FW: Request for Assistance

References below are from the 2021 IRC:

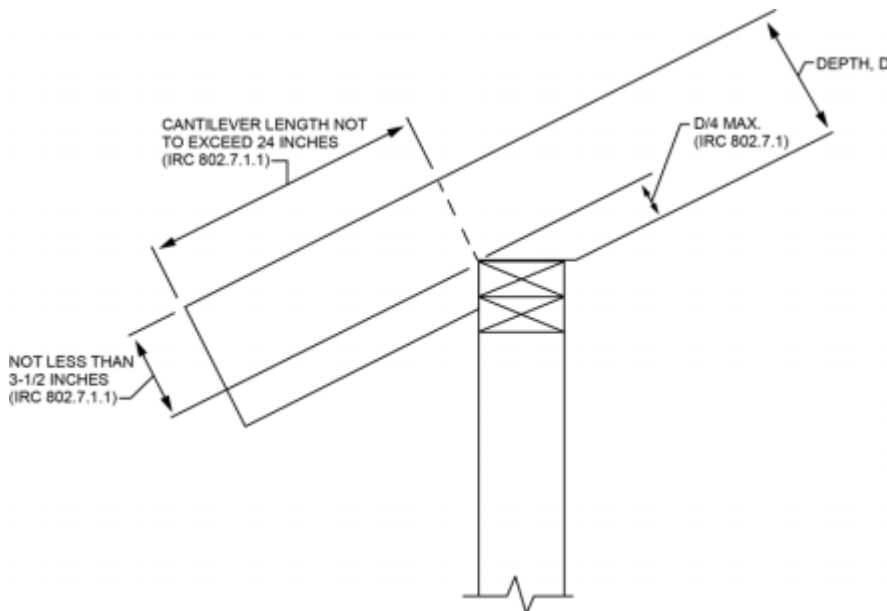
These limits are intended to maintain the strength of rafters at their bearing. The taper cuts shown on the bottom of the rafters in the photos you provided will induce significant shear stresses on the rafter where it bears at the inside face of the top plate. A split will likely form at that location compromising the load-carrying capacity of the rafter. This is particularly problematic for what appears to be a hip rafter in at least one photo.

IRC Figure R802.7.1.1 shows what is commonly referred to as a “birds-mouth” notch. Note that the taper cut on the bottom of the rafter does not extend beyond the inside face of the top plate for the reasons stated above.
